**A38 Derby Junctions**

**Appendix 3.3: Options Assessment –  
Little Eaton – Options 2A, 2B, X and X1**

## **Options Assessment: Little Eaton Options 2A, 2B, X and X1**

**Report No: 47071319-URS-06-RP-RDN-024  
July 2016**

Drawing Title  
**LITTLE EATON  
OPTION 2B  
GENERAL LAYOUT  
PLAN**

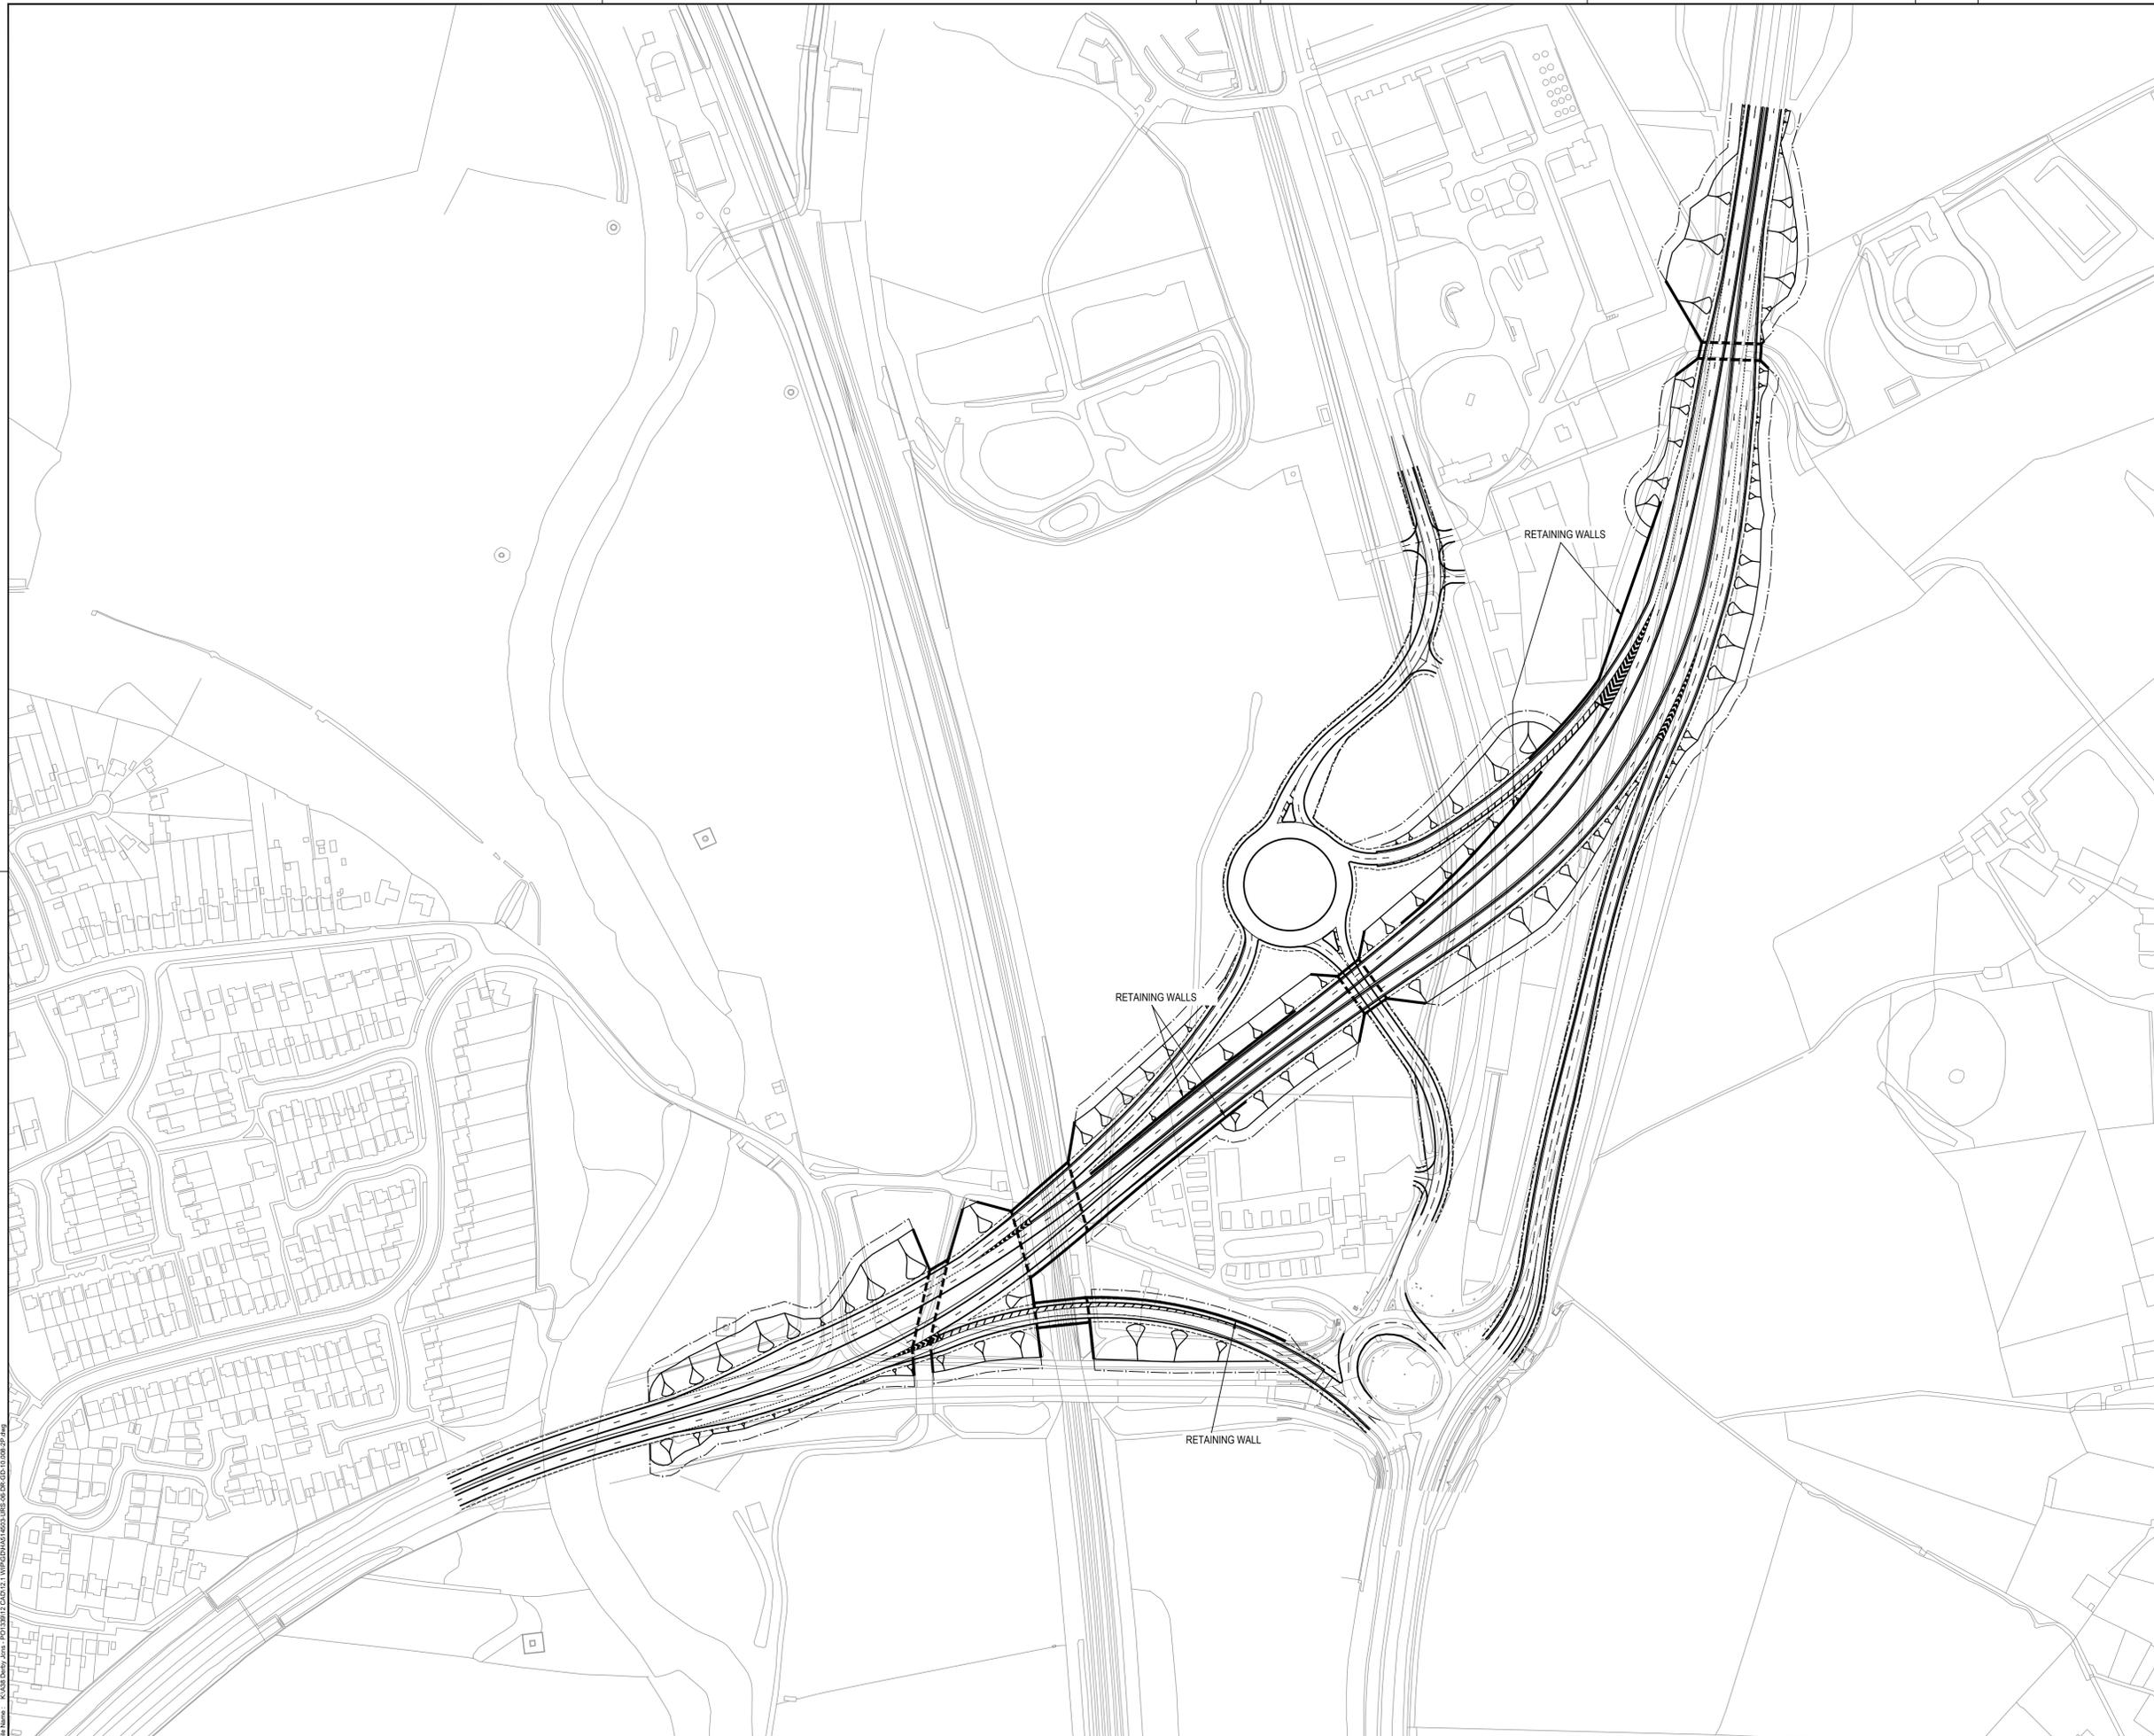
Reference		Description of the Alternative Option
Option 2B		This option is a development of Option 2A whereby the A38 southbound slip roads are adjacent to the main carriageway to form a conventional two-bridge grade-separated layout with a single roundabout. The existing roundabout and slip roads would be removed and landscaped. See drawing no. HA514503-URS-06-DR-GD-10.006.
Submitted by:		
Breadsall A38 Action Group		
Alternative option for Little Eaton Junction		
Objectives Categorisation		
Objective Description	Score	Comments
<b>Objective 1</b> 'To reduce congestion and increase reliability of journey times on the strategic corridor'	4	The option is comparable to Option 2A in that the changes are limited to the southbound slip roads only and, in terms of traffic congestion, do not make a significant change.
<b>Objective 2</b> 'To minimise traffic disruption due to construction works and incidents'	4	Compared to the Option 2A there is little change in traffic disruption during construction. The works to construct the new southbound slip roads and remove the existing A38 (which would be re-used under Option 2A) can be mostly completed offline.

<b>Objective 3</b> 'To achieve optimum whole life costs taking into account future maintenance and operation, and disruption to users'	3	Compared to Option 2A, this option differs in cost terms as follows: - lower construction cost and future maintenance cost due to need for a single bridge at the railway; - additional construction cost due to the need to demolish the existing railway bridge and A38 carriageway; - cost to purchase an additional section of the mobile home park; - cost to purchase the property "Fourways" and compensate the associated business On balance, overall whole life cost will be similar to Option 2A.
<b>Objective 4</b> 'To minimise impacts on both the natural and built environment, including designated landscape/biodiversity features'	2	This layout is comparable to Options 2 and 2A in that (i) there will be a reduced visual impact for residents in Breadsall compared to the Presented Option; (ii) there will be a large impact to the mobile homes park due to the proximity of the route and land take - although the number of mobile homes is increased compared to Option 2A; (iii) new bridge over the railway would have adverse effect on World Heritage Site and cause additional landscape effects; (iv) potential additional ecological and flood risk impacts as compared to Presented Option; and (vi) there will be the need to purchase the property "Fourways" on Ford Lane with likely impacts to the adjacent business. Note: Without the proposed amendments to the garden centre car park, the land take would result in its potential closure .

<b>Objective 5</b> 'To seek to mitigate impacts on air quality and noise'	3	The score is comparable to Options 2 and 2A. Option 2B would reduce air quality effects in some locations and increase them elsewhere as compared to the Presented Option, whilst the overall noise effects of Option 2B are likely to be neutral as compared to the Presented Option.
<b>Objective 6</b> 'To improve the safety for all road users'	3	The score is comparable to Option 2 as there are no significant changes to the overall alignment which would affect road user safety.
<b>Objective 7</b> 'To seek to reduce severance by maintaining or providing appropriate facilities for crossing, and travelling along the route for non-motorised users'	3	The score is comparable to Option 2 as there are no significant changes planned which would affect NMUs. No NMU routes will be permanently severed. Access to adjacent land holdings is severely impacted. Crossing points would be provided where required.

<b>Objective 8</b> 'To be affordable and represent High Value for Money according to DfT's appraisal criteria'	3	Scheme is expected to represent good value for money in terms of BCR. Compared to the Presented Option, benefits are expected to be similar (see objective 1) but costs are expected to be higher (see objective 3). In addition, there will be additional costs associated with purchasing more mobile homes and the currently viable garden centre business. Overall, this results in a lower score compared to the Presented Option.
<b>Average Score</b>	3.125

Reference		Description of the Alternative Option
Option 2B		This option is a development of Option 2A whereby the A38 southbound slip roads are adjacent to the main carriageway to form a conventional two-bridge grade-separated layout with a single roundabout. The existing roundabout and slip roads would be removed and landscaped. See drawing no. HA514503-URS-06-DR-GD-10.006.
Submitted by:		
Breadsall A38 Action Group		
Alternative option for Little Eaton Junction		
Deliverability Categorisation		
Factors considered	Score	Comments
<p>Is there a risk that will prevent us from progressing this option?</p> <p>What level of stakeholder/public support/challenge is expected for this option?</p> <p>Are there any significant third party issue associated with the option?</p> <p>Are there any political issues associated with this option?</p> <p>Are there any planning/legal issues associated with this option?</p> <p>Does the option impact the overall project deliverability?</p>	2	<p>As for Option 2A, this option requires the CPO of land currently occupied by the car park to the Derby Garden Centre. The area of land is sufficiently large to make the garden unviable as an ongoing business. The option proposes purchasing land from the existing landfill site to replace the lost car park area.</p> <p>Examination of the CPO powers, governed under the Planning Act 2008 for Development Consent Order (DCO) applications, has shown that this is not possible under legislation. The powers only relate to purchasing land that is an integral part of the principle proposed development or defined as associated development. The Department for Communities and Local Government guidance on associated development lays out the type of land that can be included. The proposed arrangement is not listed within the guidance and hence, is not covered by the legislation. Pursuing such an arrangement would therefore be beyond the legal powers.</p> <p>As a consequence, the only way this land could be obtained for the purpose of a replacement car park would be by negotiation. As the scheme could not proceed without the land, this would form a "ransom strip" whereby the landowner could effectively control the price of the land. This is expected to be costly and difficult to secure until later stages in the project when funding is available. This puts the project at risk and presented a major deliverability challenge.</p> <p>As such, the only remaining option would be to purchase the Derby Garden Centre. This is estimated at £2m and contributes to the higher project cost (see objective 3). Consequently, this presents a major deliverability challenge. In the event that the amended car park could not be provided, the only alternative would be for the car park to be extended south, into the land owned by Garden Centre, with foot access provided around the junction from the car park to Garden Centre (approx. 300m walking distance). However, this is unlikely to be either safe or practicable and would be likely to lead to the business becoming unviable.</p>

Feasibility Categorisation		
Factors considered	Score	Comments
<p>Is the option technically sound?</p> <p>Is the option financially affordable?</p> <p>Is the option buildable?</p> <p>Is the option likely to be practical and effective?</p> <p>Does the option impact the overall project feasibility</p>	3	No additional benefits or drawbacks when compared with Presented Option.

Drawing Title  
**LITTLE EATON  
OPTION 2A  
SINGLE BRIDGE OPTION  
GENERAL LAYOUT  
PLAN**

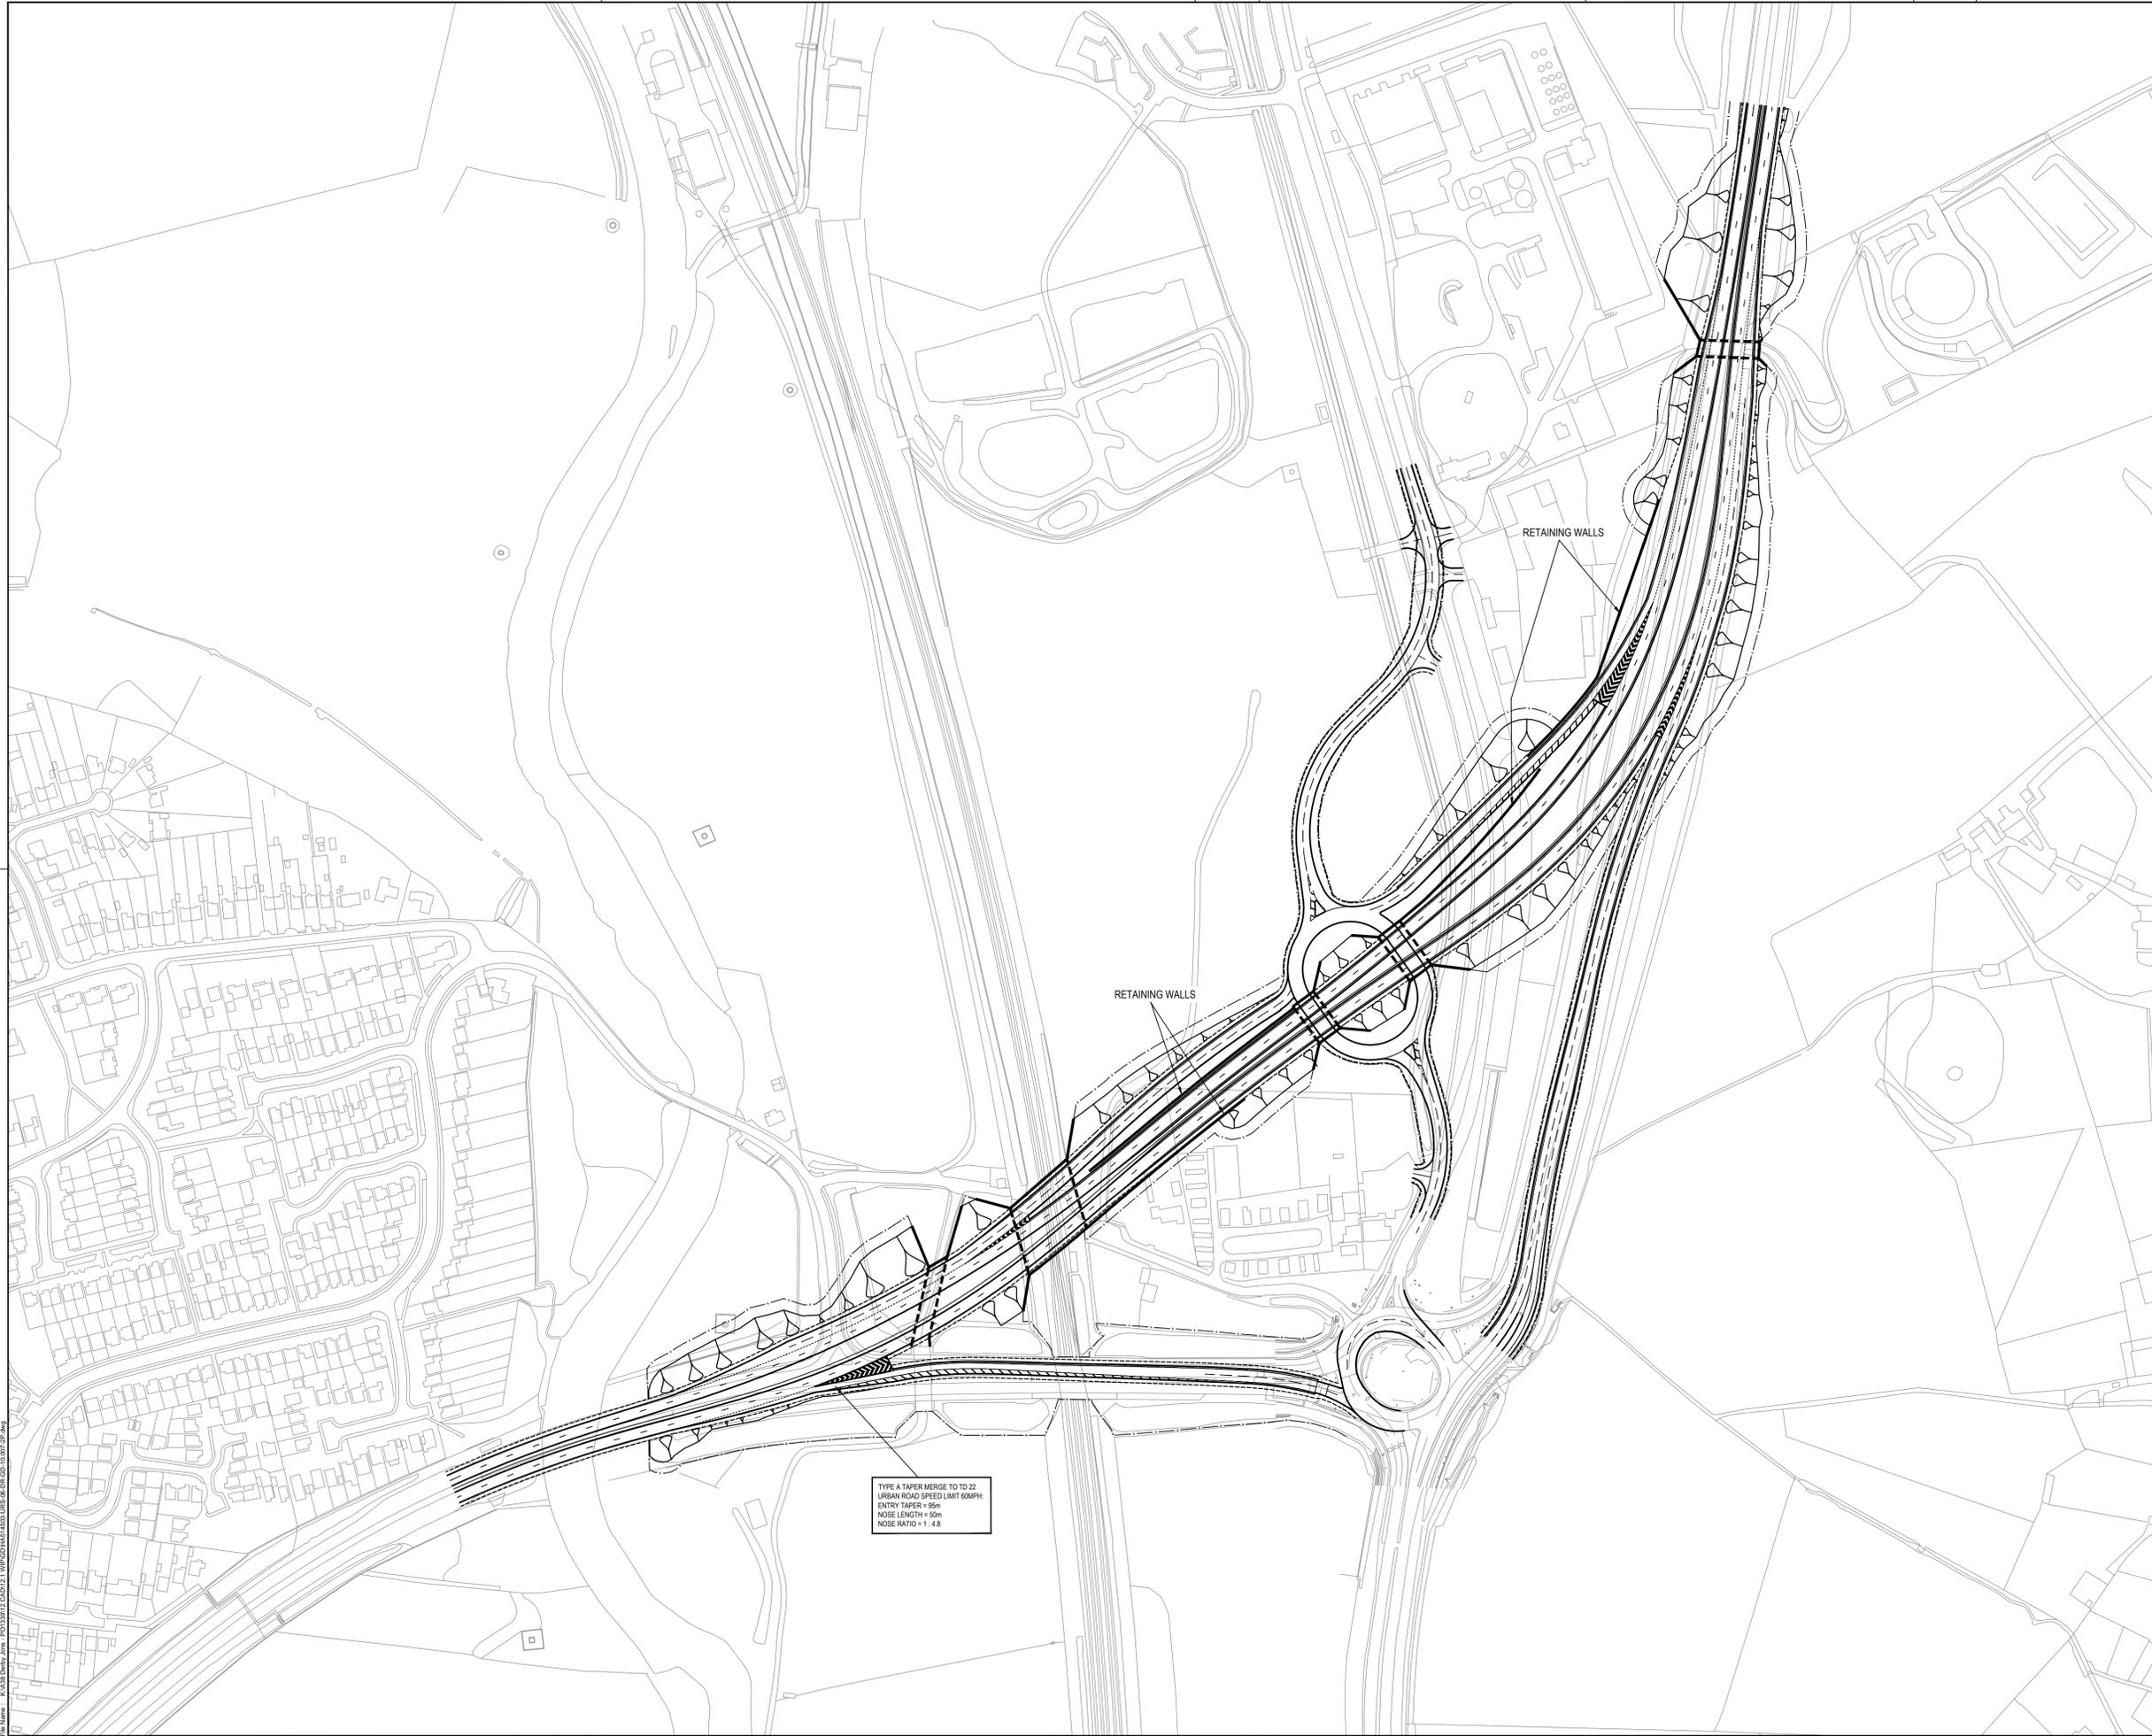
Reference		Description of the Alternative Option
Option 2A (single bridge variant)		This option is a development of Option 2A whereby the northern roundabout is moved northwards such that only a single underbridge is needed to the A38. See drawing no. HA514503-URS-06-DR-GD-10.008.  Note that the drawing also shows the re-aligned southbound entry slip road. However, for the purpose of the assessment, the slip road alignment has been assumed to be that for Option 2A.
Submitted by:		
n/a - Developed from Option 2A by AECOM		
Alternative option for  Little Eaton Junction		
Objectives Categorisation		
Objective Description	Score	Comments
<b>Objective 1</b> 'To reduce congestion and increase reliability of journey times on the strategic corridor'	4	The option is comparable to Option 2A as the changes are limited to the location of the northern roundabout and minor alterations to the slip road alignments.

<b>Objective 2</b> 'To minimise traffic disruption due to construction works and incidents'	4	The option is comparable to Option 2A. The changes will not have a significant effect on the construction methodology, construction duration or traffic management arrangements.
<b>Objective 3</b> 'To achieve optimum whole life costs taking into account future maintenance and operation, and disruption to users'	3	Compared to option 2A, this option will result in lower construction and future maintenance costs associated with only a single bridge being required. In all other regards the costs of construction and maintenance will be comparable.
<b>Objective 4</b> 'To minimise impacts on both the natural and built environment, including designated landscape/biodiversity features'	2	The option is comparable to Option 2A as the changes are limited to the location of the northern roundabout, although additional land take associated with northern roundabout would potentially increase impacts associated with ecology and flood risk (as compared to Option 2A).

<b>Objective 5</b> 'To seek to mitigate impacts on air quality and noise'	3	The option is comparable to Option 2A as the changes are limited to the location of the northern roundabout.
<b>Objective 6</b> 'To improve the safety for all road users'	3	The option is comparable to Option 2A as the changes are limited to the location of the northern roundabout.
<b>Objective 7</b> 'To seek to reduce severance by maintaining or providing appropriate facilities for crossing, and travelling along the route for non-motorised users'	3	The option is comparable to Option 2A as the changes are limited to the location of the northern roundabout.
<b>Objective 8</b> 'To be affordable and represent High Value for Money according to DfT's appraisal criteria'	3	The option is comparable to Option 2A as, although the whole life cost will be reduced, the magnitude of the saving is not expected to be large enough to significantly improve the scheme BCR.

<b>Average Score</b>	<b>3.125</b>	
Deliverability Categorisation		
Factors considered	Score	Comments
Is there a risk that will prevent us from progressing this option? What level of stakeholder/public support/challenge is expected for this option? Are there any significant third party issue associated with the option? Are there any political issues associated with this option? Are there any planning/legal issues associated with this option? Does the option impact the overall project deliverability?	2	The option is comparable to Option 2A as the changes are limited to the location of the northern roundabout.
Feasibility Categorisation		
Factors considered	Score	Comments
Is the option technically sound? Is the option financially affordable? Is the option buildable? Is the option likely to be practical and effective? Does the option impact the overall project feasibility	3	The option is comparable to Option 2A as the changes are limited to the location of the northern roundabout.
